**LEBANON PLANNING BOARD
JUNE 10, 2024 - 6:30 PM
COUNCIL CHAMBERS, CITY HALL OR
REMOTE VIA VIRTUAL PLATFORM
LEBANONNH.GOV/LIVE**

Staff Memorandum – PB2024-12-SPA – *postponed from 5/13/24*

PB2024-12-SPA

RE: Site Plan Review Application
DHMC Parking Lot Expansions
Tax Map 10 Lots 8

C104
 Page 8 of 27

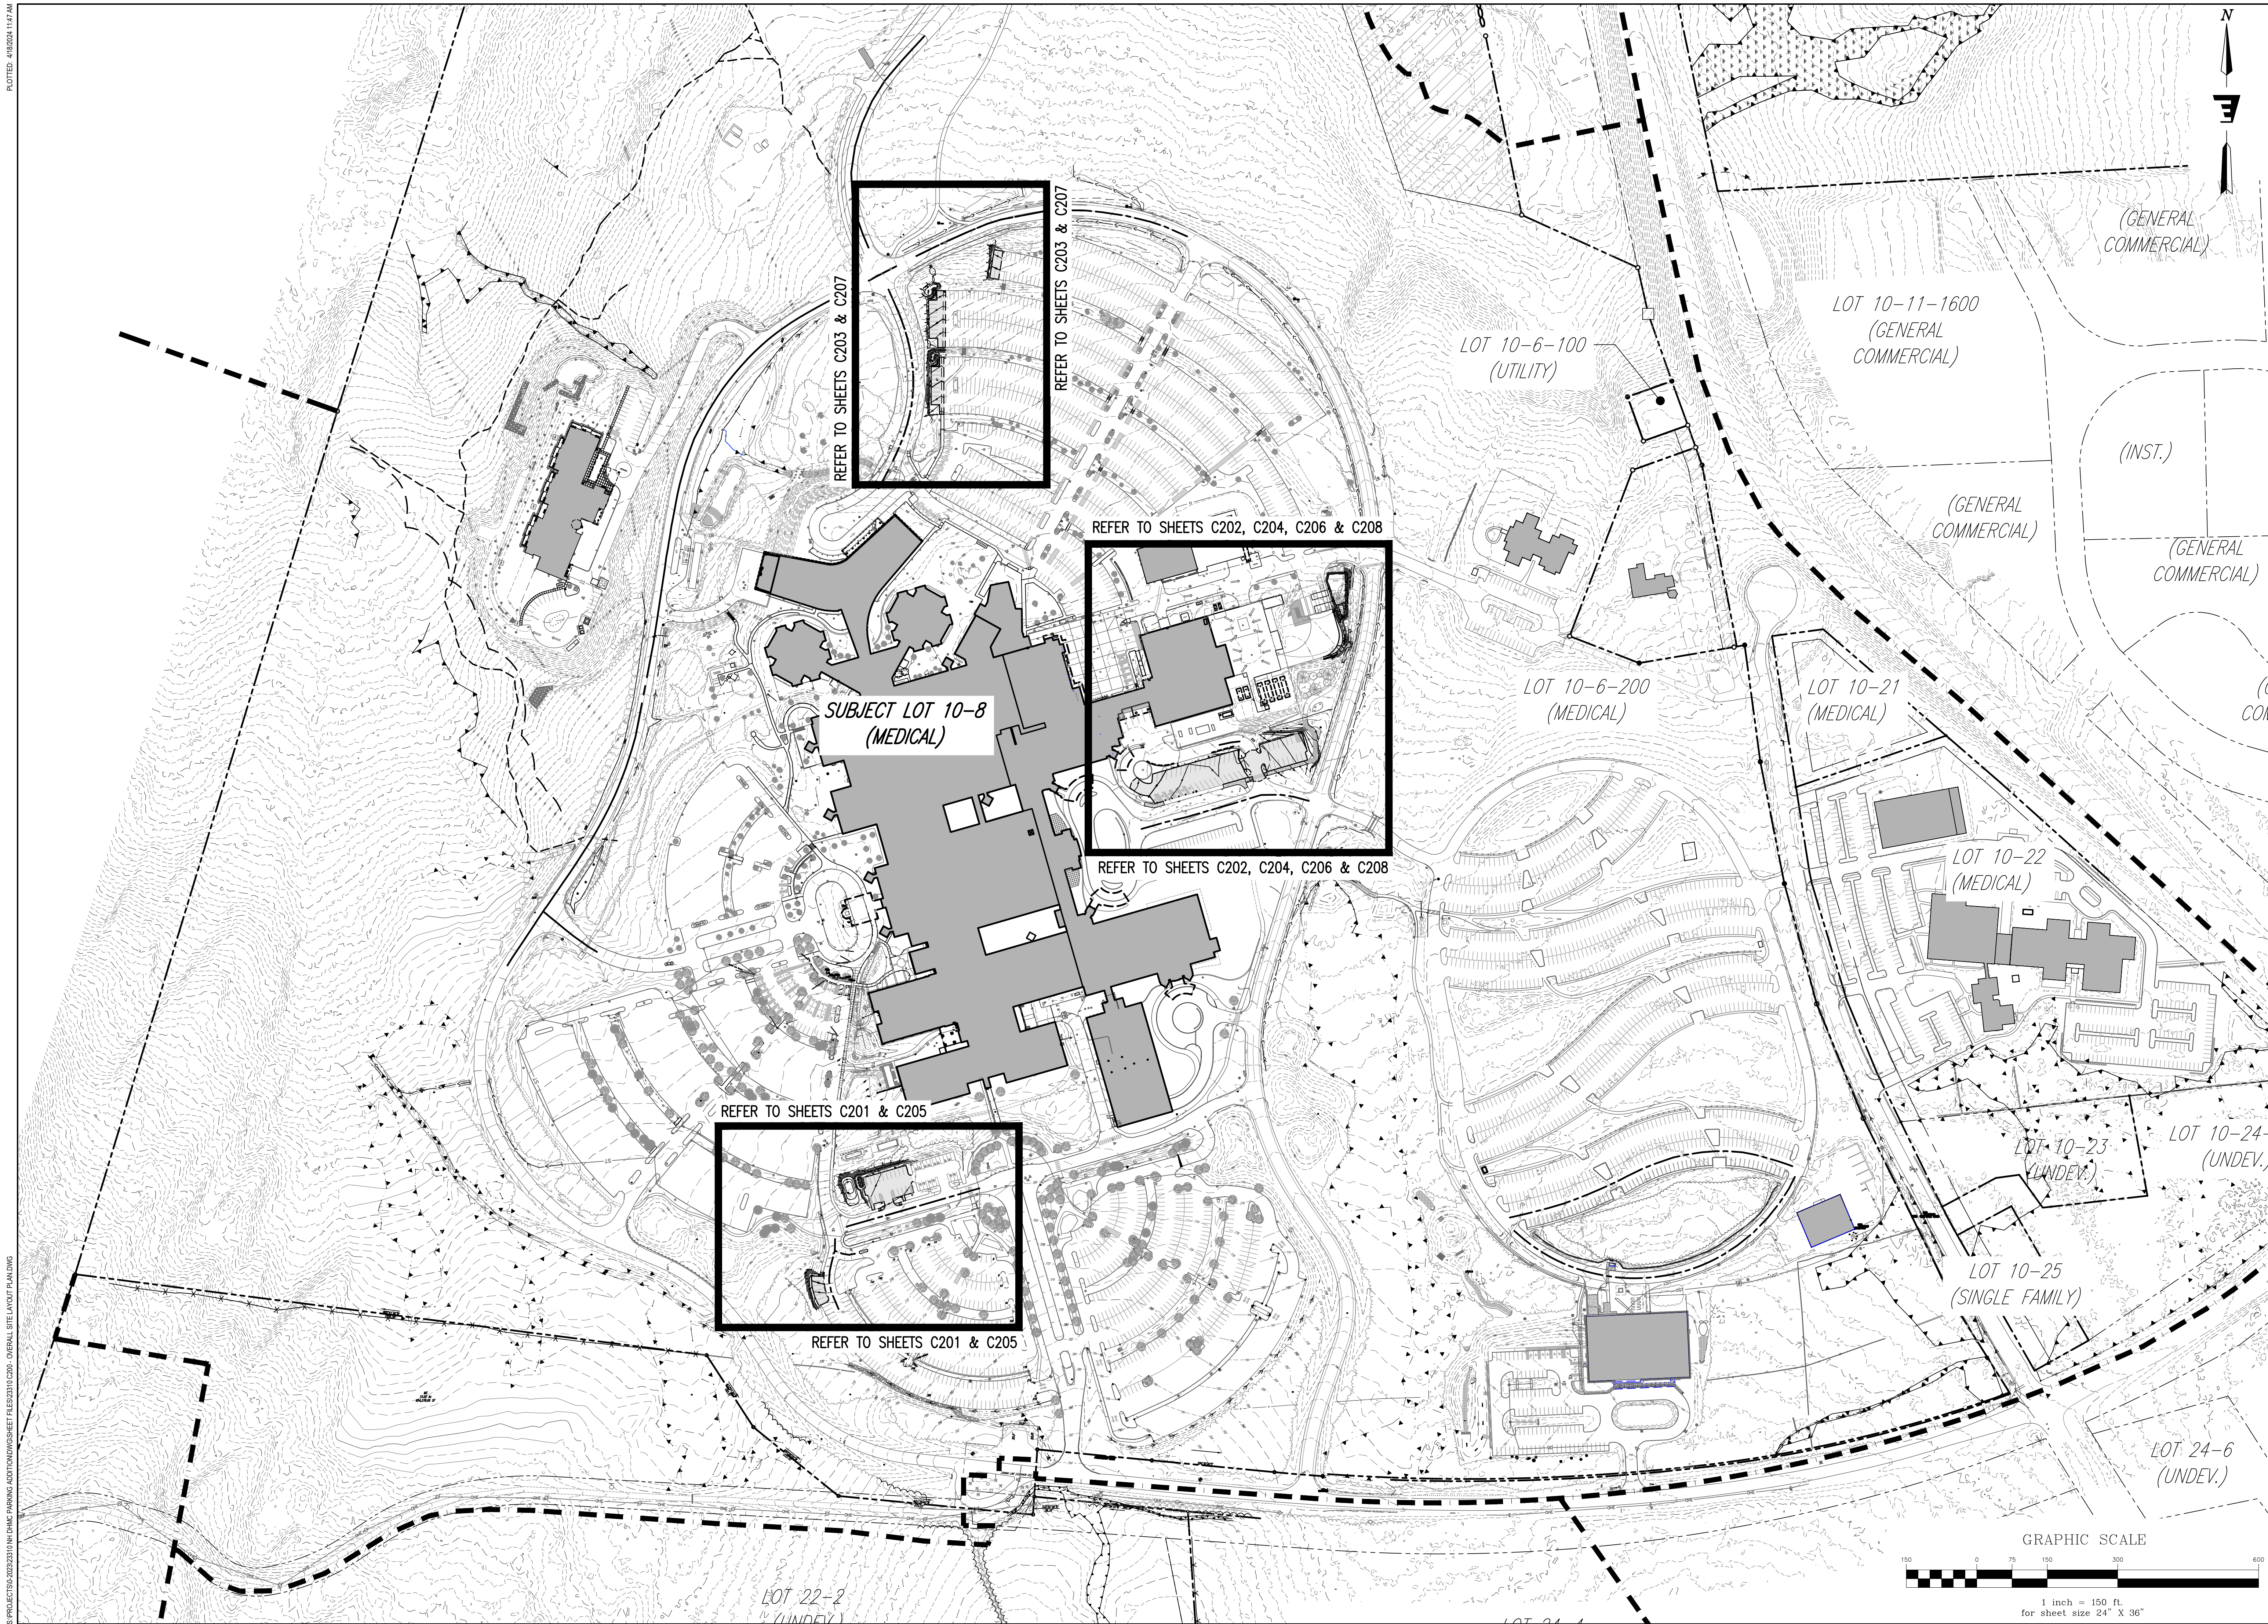
- Demo items have been added to existing conditions plans; sheets C101-C104
- **Sheet 8 (C104) is mislabeled along the bottom of the sheet as "SITE PLAN"**

SITE PLAN - PARKING AREA "2"

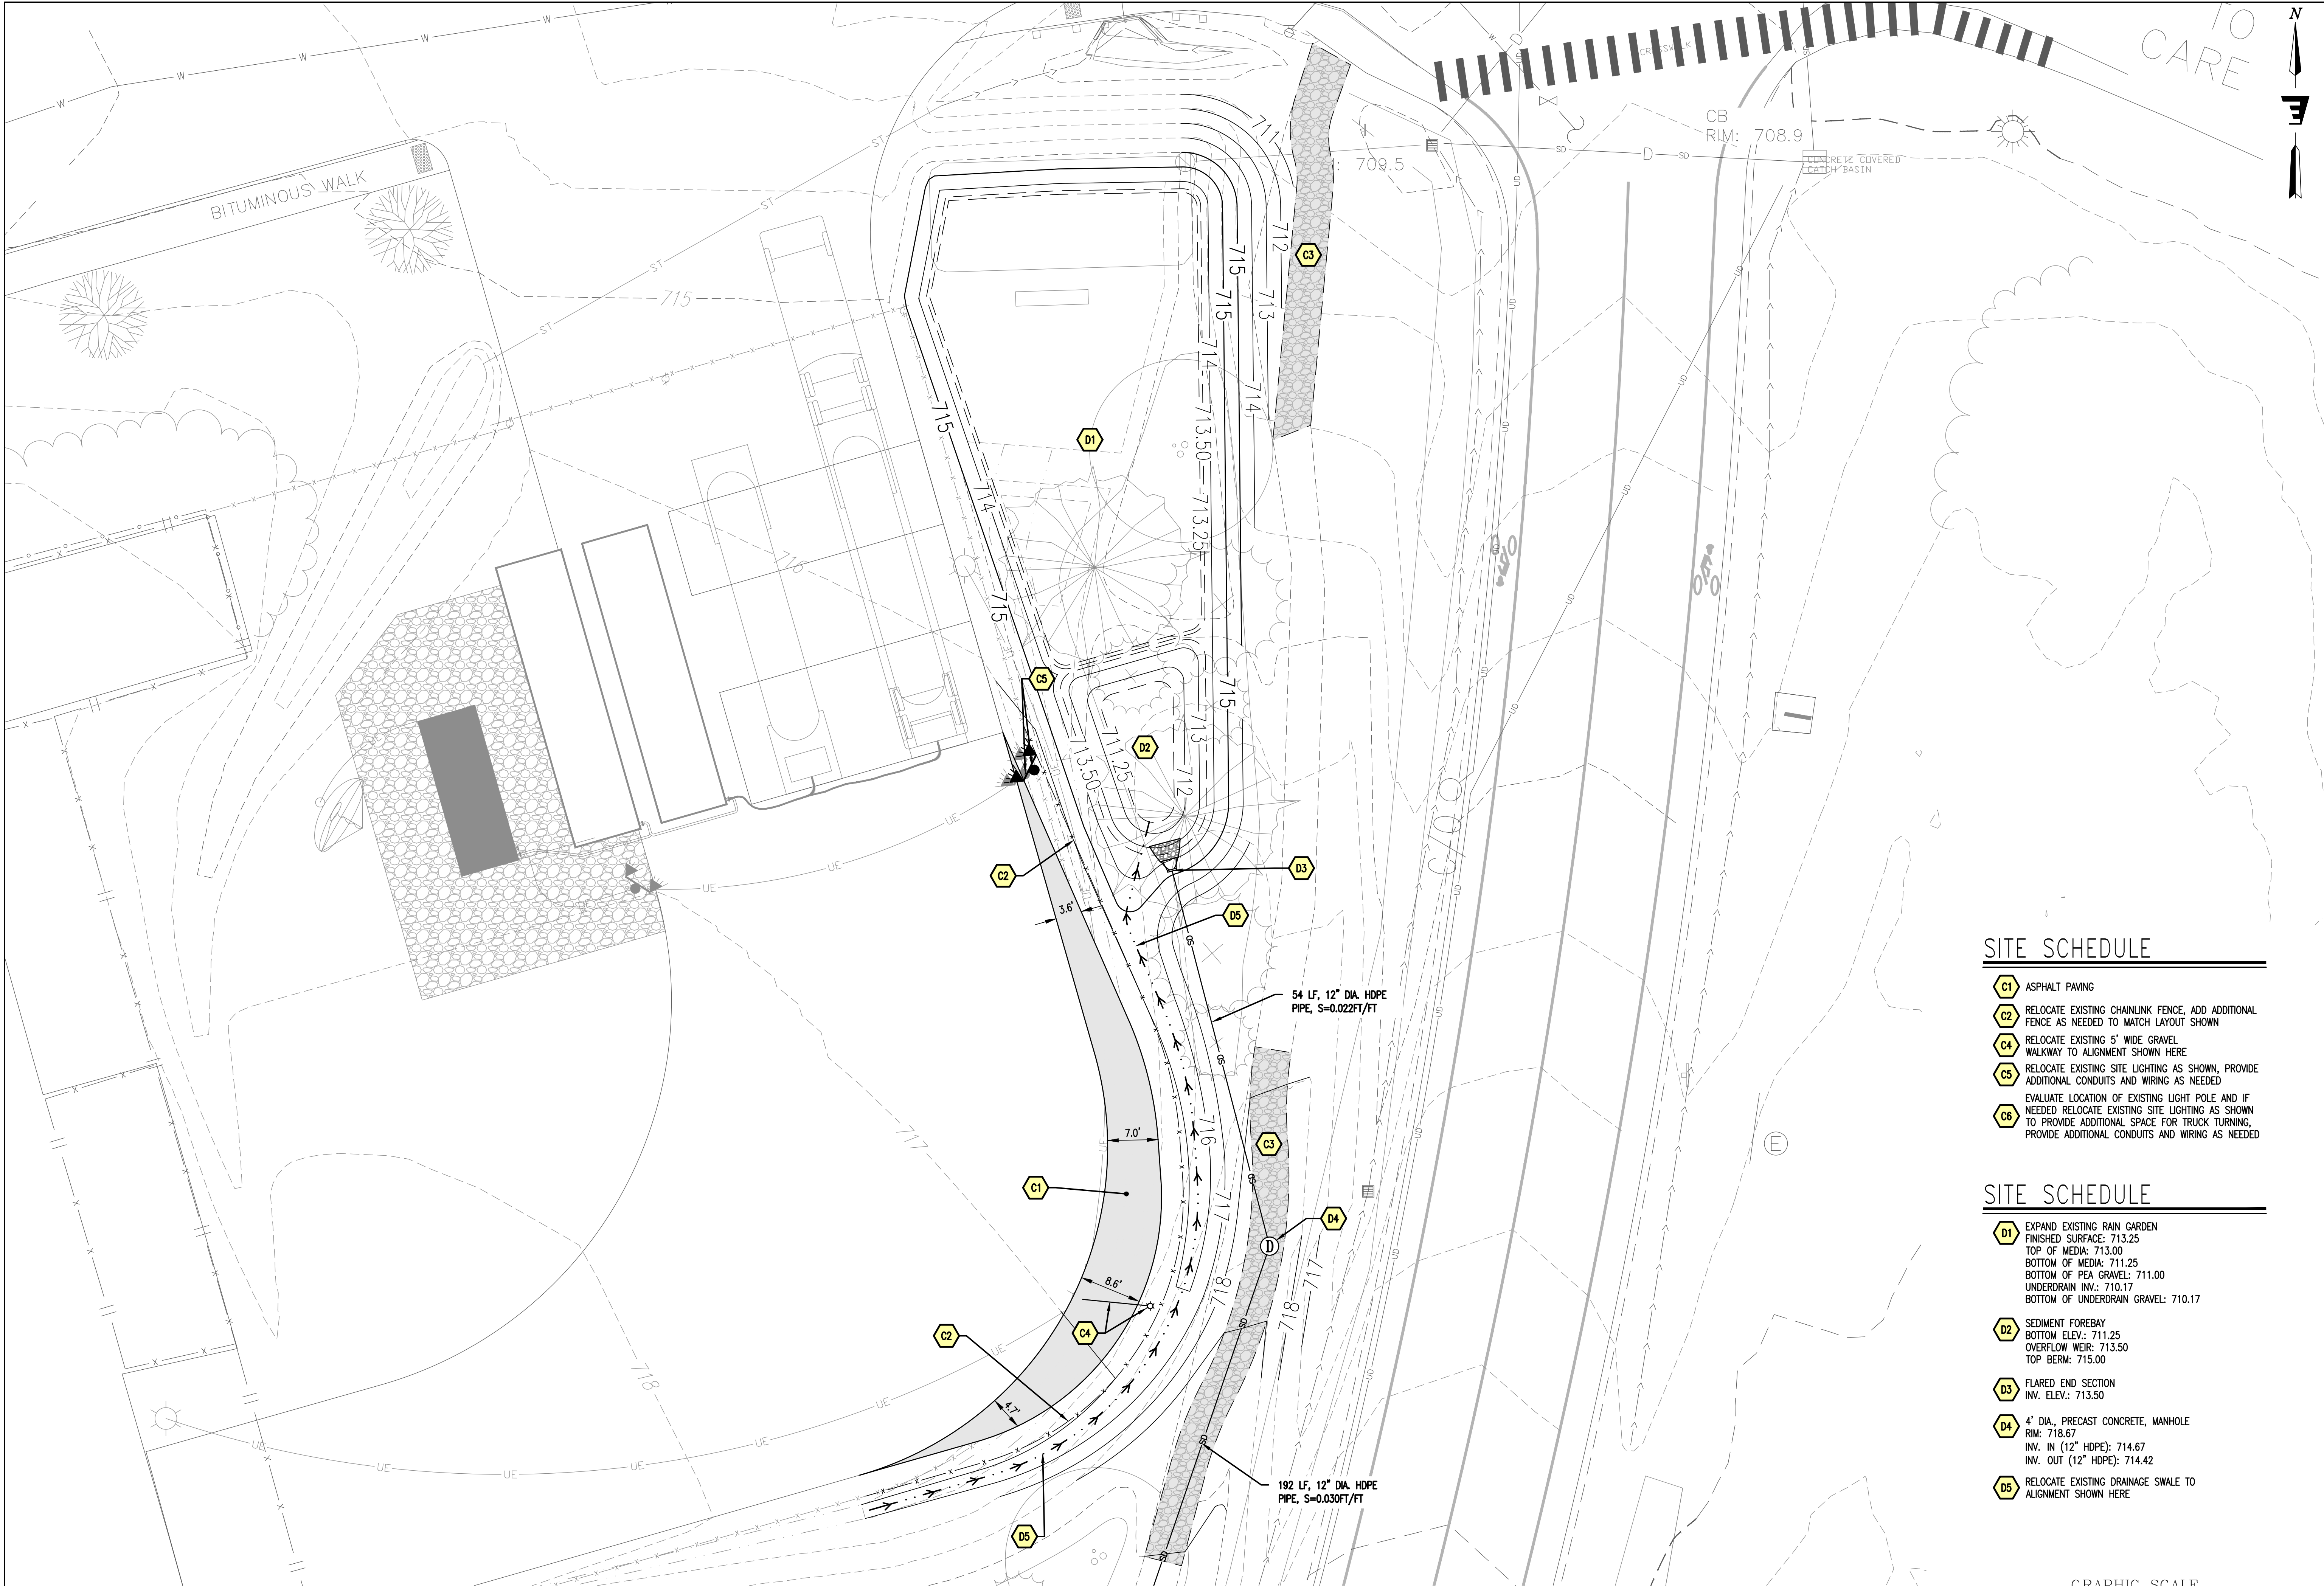
- The parking spaces have been renumbered. Please note that the Lot 2 work includes repaving two (2) existing parking spaces, and they are labeled as E1 and E2 on sheet C203.

LANDSCAPE PLAN - PARKING AREAS "4" AND "8"

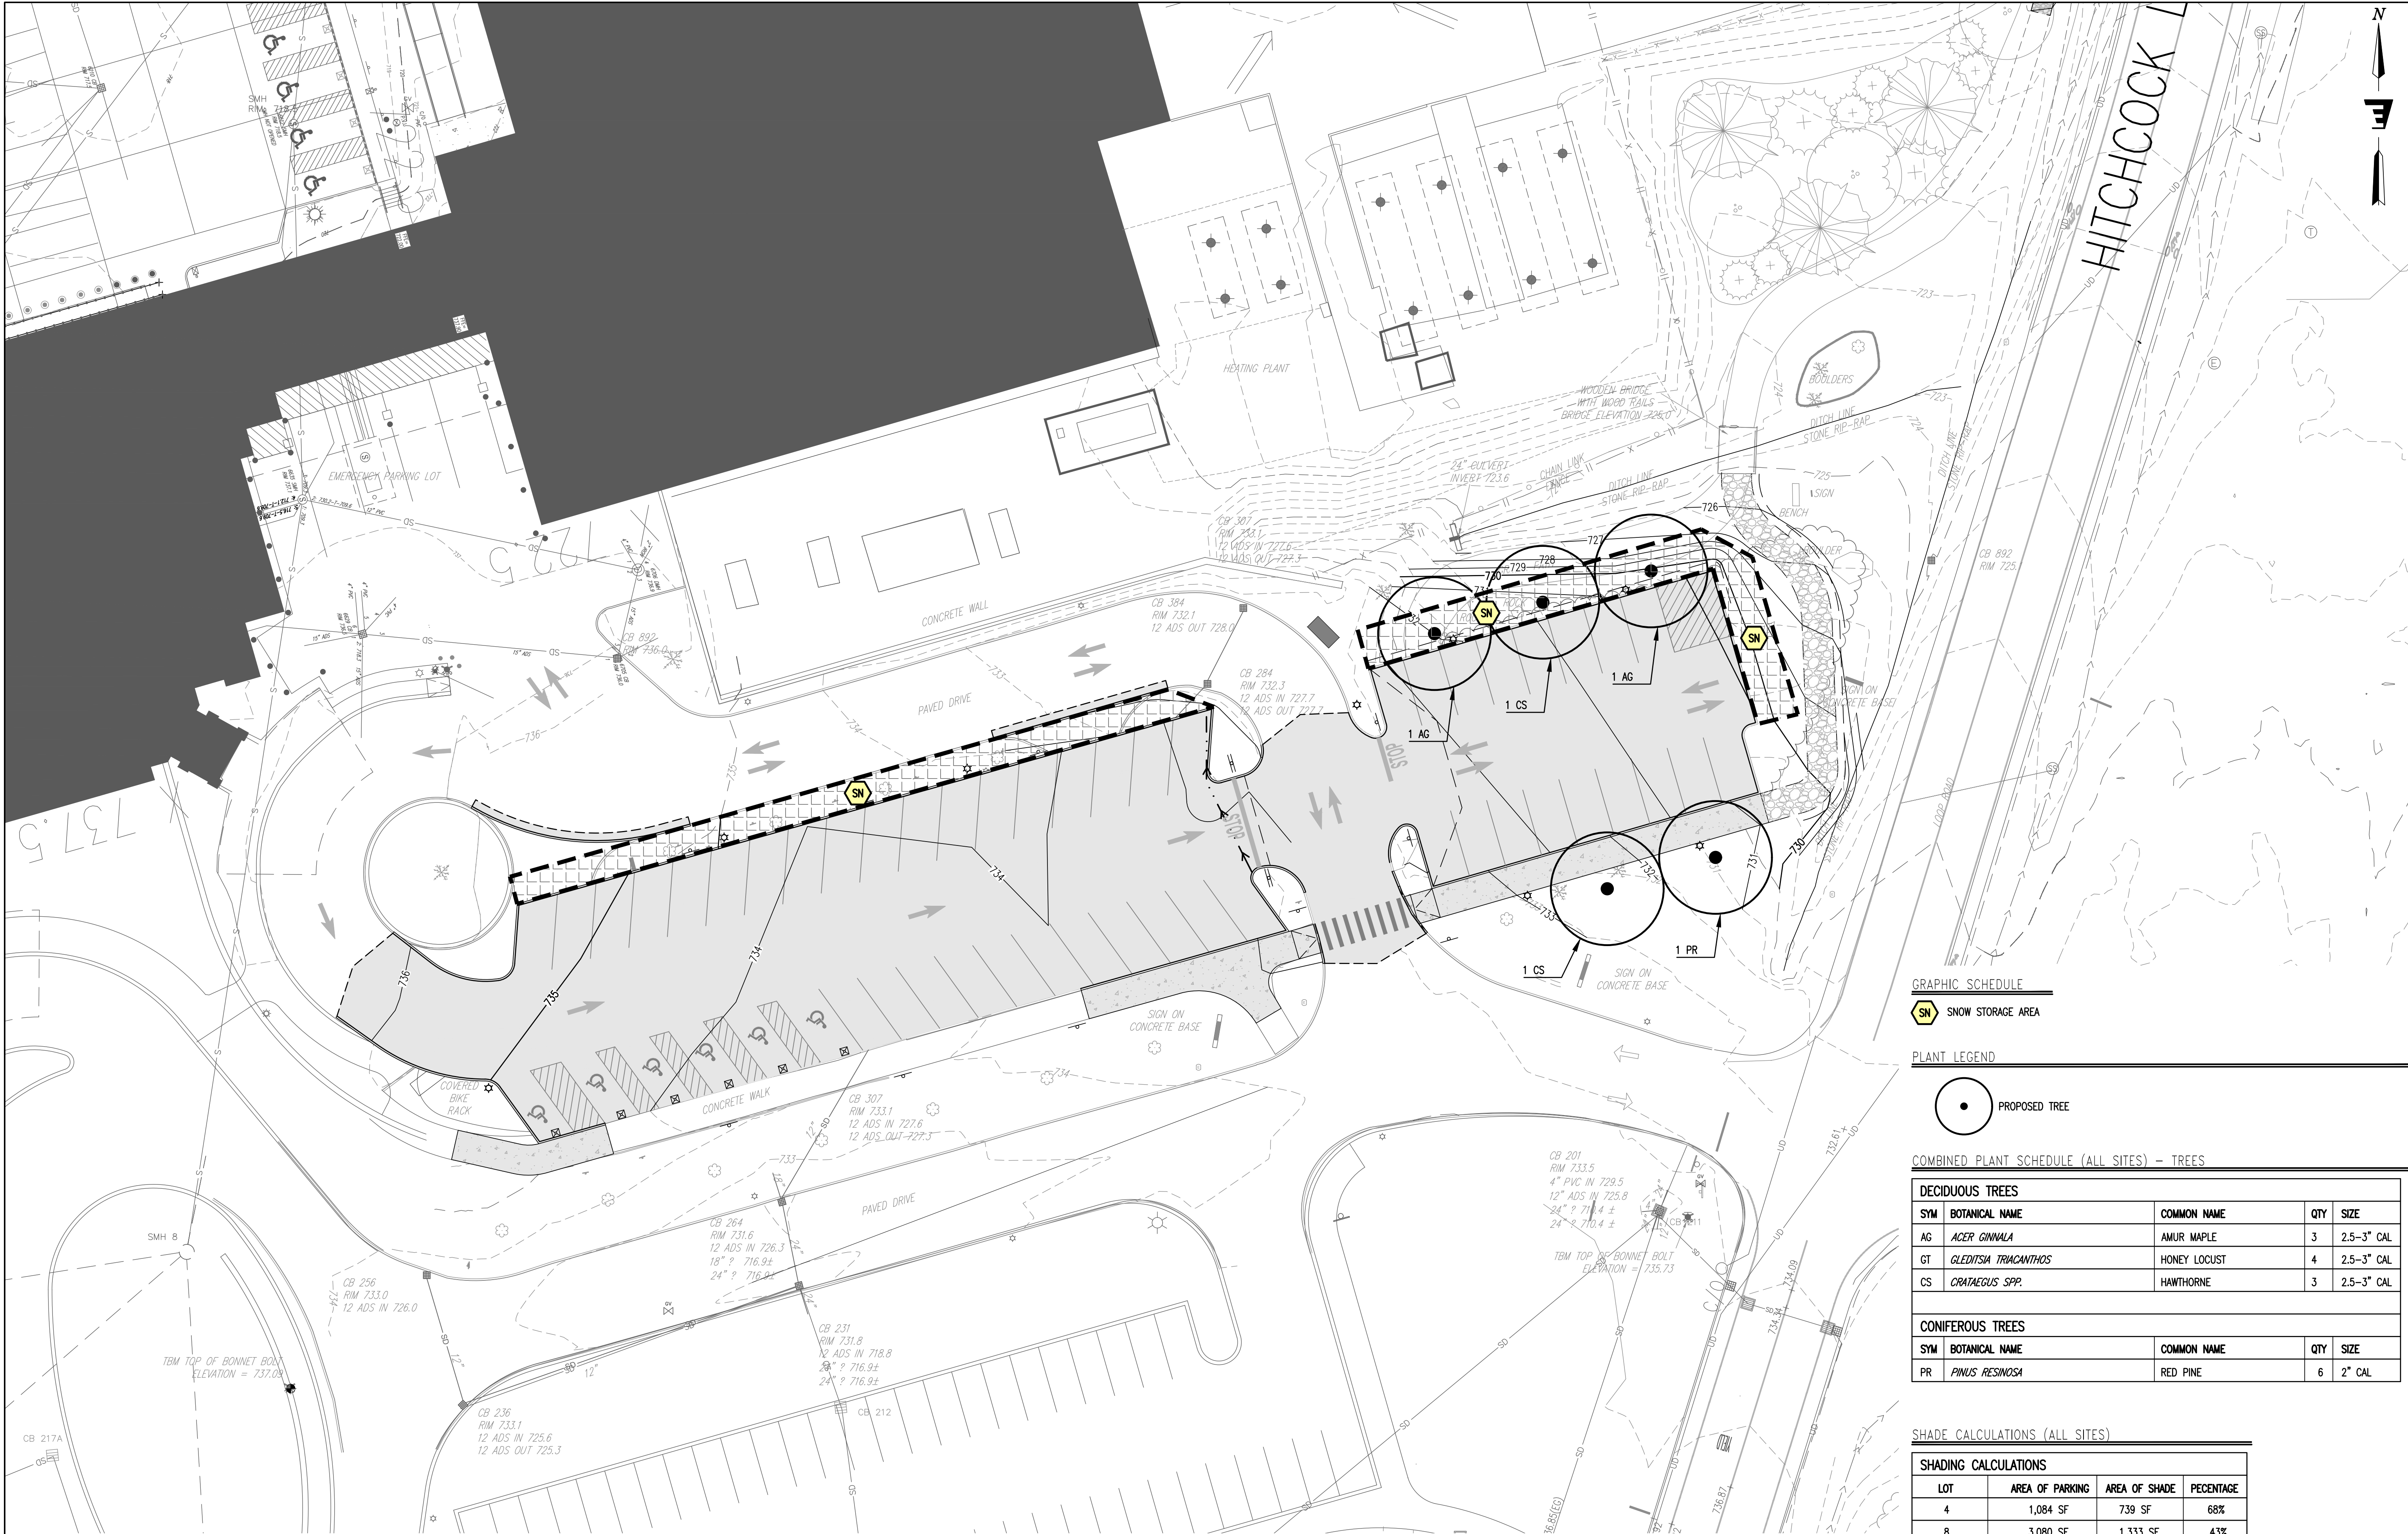
The indicated parking zones exceed 100 feet in length and fail to include the mandated dispersion of landscaped beds, each measuring at least 8 feet by 8 feet, spaced every 100 feet or less. See sheet C211

- Sheet C211 consists of two separate lots that have been misinterpreted as one continuous parking row. The longest row in each added parking area is 81 feet.
